# UNITED STATES PATENT AND TRADEMARK OFFICE

10/773,033

<b>Office Action Summary</b>	<b>Application No.</b> 10/773,033	<b>Applicant(s)</b> MOON ET AL.	
	<b>Examiner</b> Timothy M. Ayres	<b>Art Unit</b> 3637

### **DETAILED ACTION**

Hsu '759 Figure 1

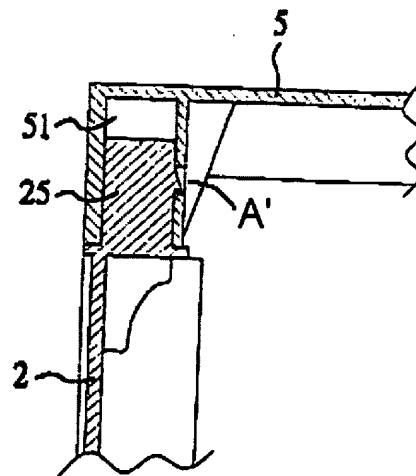
11. Claims 1, 2, 11-16 are rejected under 35 U.S.C. 103(a) as being unpatentable over US Patent 6,474,759 to Hsu in view of US Patent 4,193,649 to Sharon. Hsu teaches a plastic cabinet that can have drawers as seen in figure 11. The cabinet is made up of a base panel (1), top panel (5), left side panel (2), right side panel (3), and back panel (4). The top and bottom panels (1,5) connect to the side and back panels (2,3,4) with a means for attaching (11, 12 ,51, 21,25,41,42,31,35). The means for

attaching (11, 12, 51, 21, 25, 41, 42, 31, 35) is posts (35, 42, 25, 21, 31, 41) on the side and back panels (2, 3, 4) that have integrally formed spring tabs (A') that communicate with locking sockets (11, 12, 51) in the base and top panels (1, 5) as seen in figure 1 and 7 below.

Sharon '649 Figure 2

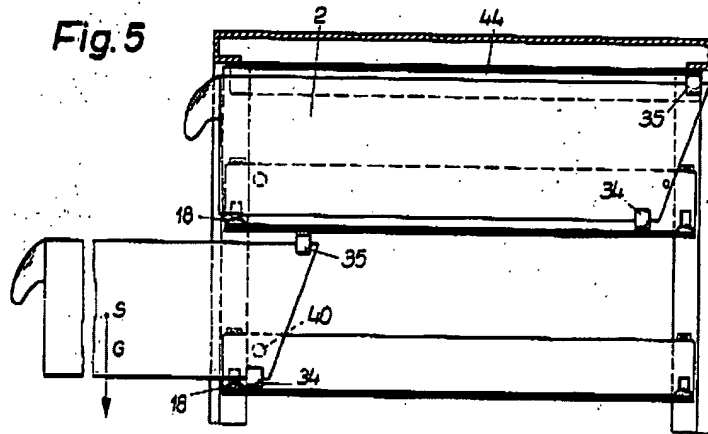
drawer glide system that includes drawer glides (51, 52) that have clips (10) to insert into apertures (21) on a vertical rail (20) . This system allows for different sized drawers to be used in the cabinet. (Col. 1, lines 39-44). The drawer has an upper and lower roller (A', B') to engage with the drawer glide (51, 52). At the time of the invention it would have been obvious for a person of ordinary skill in the art to modify the cabinet of Hsu by adding the vertical rails and drawer glide structure as taught by Sharon to allow for adjustable drawers (Sharon '649, Col. 1, lines 39-44)

Hassel '874 Figure 5

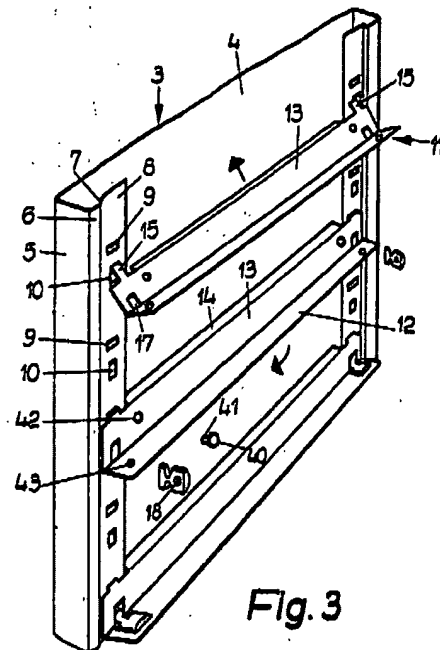
16. Hassel teaches a cabinet (1) with drawers (2). The drawer glides (11) are mounted with locking posts (16,15) that have a conjugate shape and extend through apertures (9) in integral vertical rail (8) that are formed on the side wall (3). The drawer glides (11) are L-shaped with a vertical leg (13) and horizontal leg (12). The drawers (2) have slides (34,35) and the rear portion of the drawer (2). A locking member (18) extends through an opening (17) in the vertical leg (13) of the drawer glide (11) and an aperture (10) on the vertical rail (8) to secure the drawer glide (11) in place. The upper slides (35) contact the bottom of the drawer glide (11) that is above the drawer (2) and the lower slides (34) on the drawer (2) contact a drawer glide (11) that is relatively level with the drawer (2).

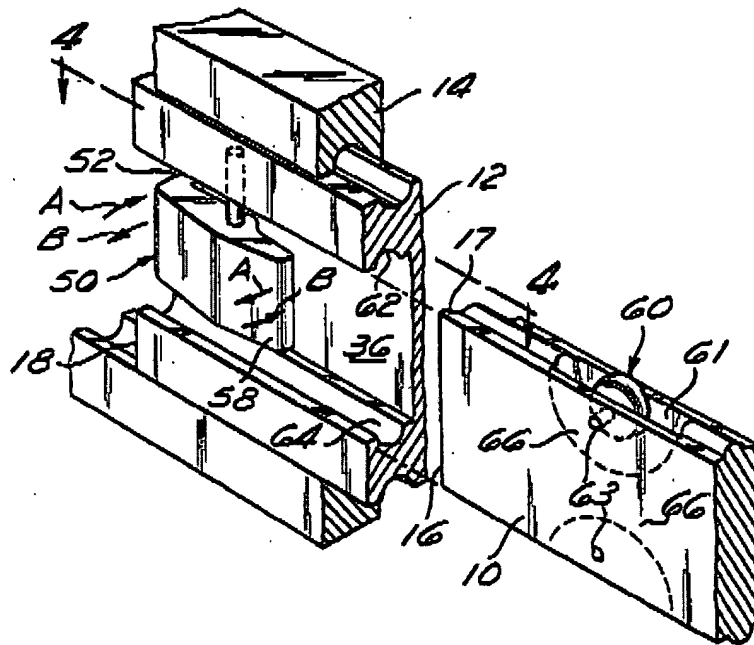
21. Regarding claim 5, Hsu in view of Hassel and Schenker does not expressly disclose a spring tab on the locking post of the drawer glide. At the time of the invention it would have been obvious for a person of ordinary skill in the art to modify the drawer cabinet of Hsu in view of Hassel and Schenker by have a spring tab on the locking post of the drawer glide since a locking member is already taught by Hassel and Hsu teaches locking post with integral formed spring tabs to couple with apertures.
